UNITED STATES PATENT AND TRADEMARK OFFICE

10/539,922

Office Action Summary	Application No.	Applicant(s)	
	10/539,922	SCHLIEMANN, ERIC	
	Examiner	Art Unit	
	DONNELL LONG	3754

DETAILED ACTION

FIG. 2

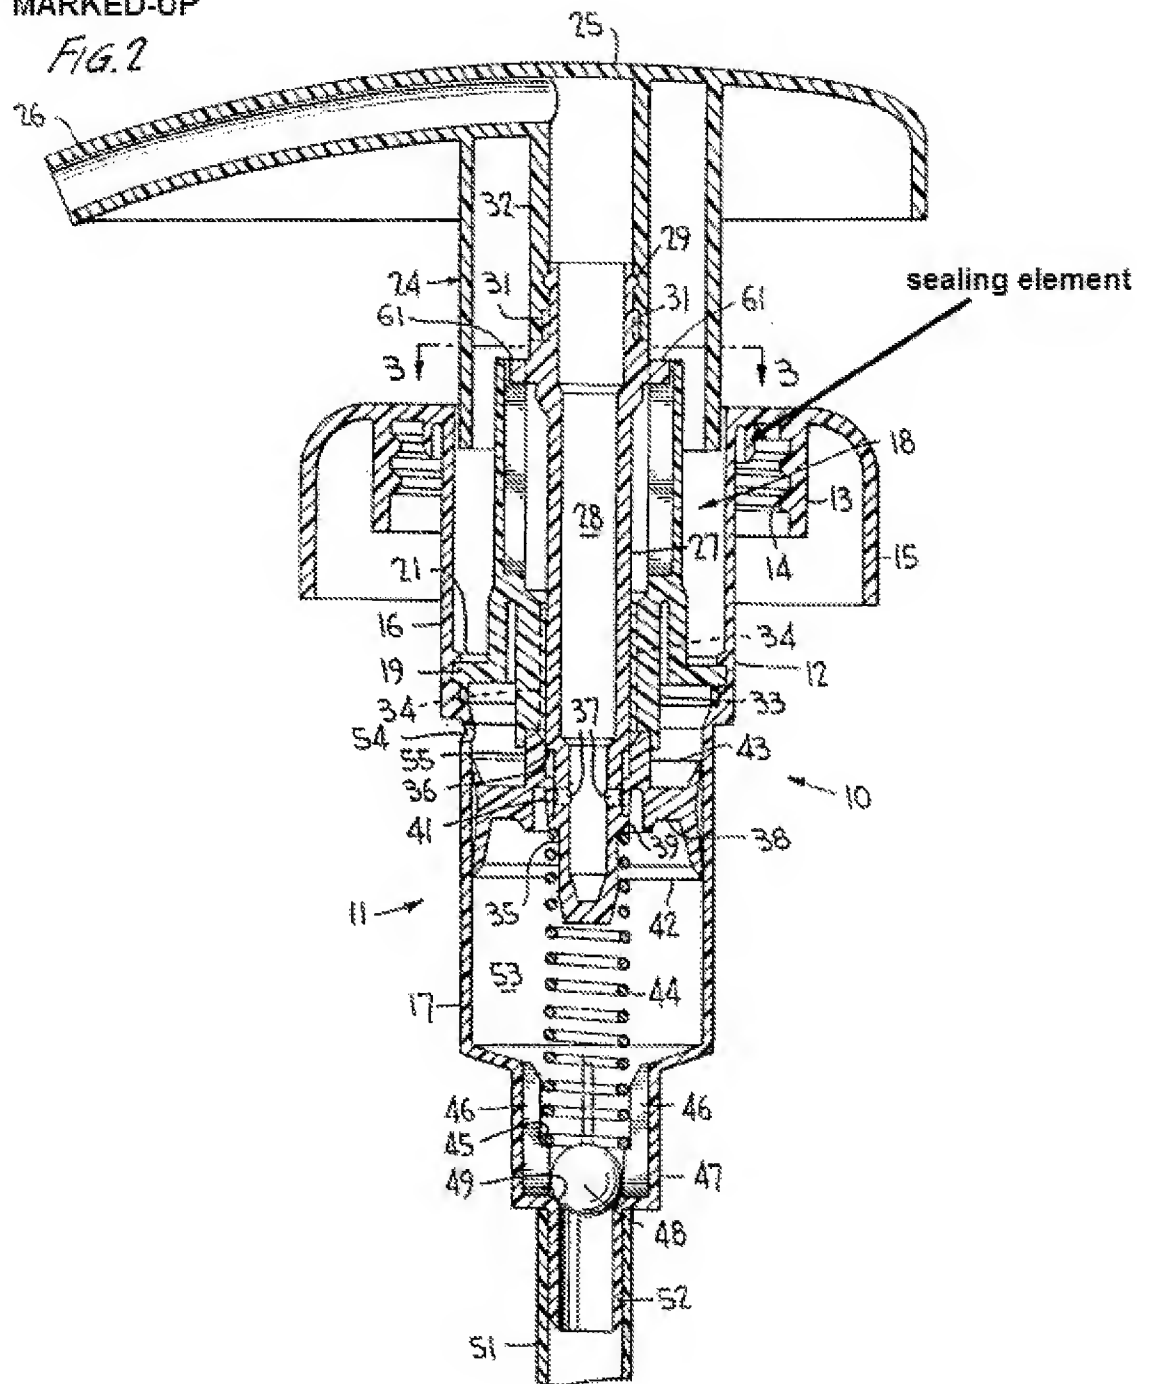
Regarding claim 1, Grothoff discloses a fluid dispenser comprising an inlet (49) and a discharge opening in a nozzle (26), wherein the inlet and the discharge opening are disposed separate from each other, a dosing and displacement chamber (53) provided between the inlet and discharge opening, wherein the inlet and discharge opening are closable by closure means (39, 41).

Regarding claim 3, the inlet opens out into the chamber (FIG. 2).

Regarding claim 9, a sealing element (see marked-up FIG. 2) is disposed in the screw fastening.
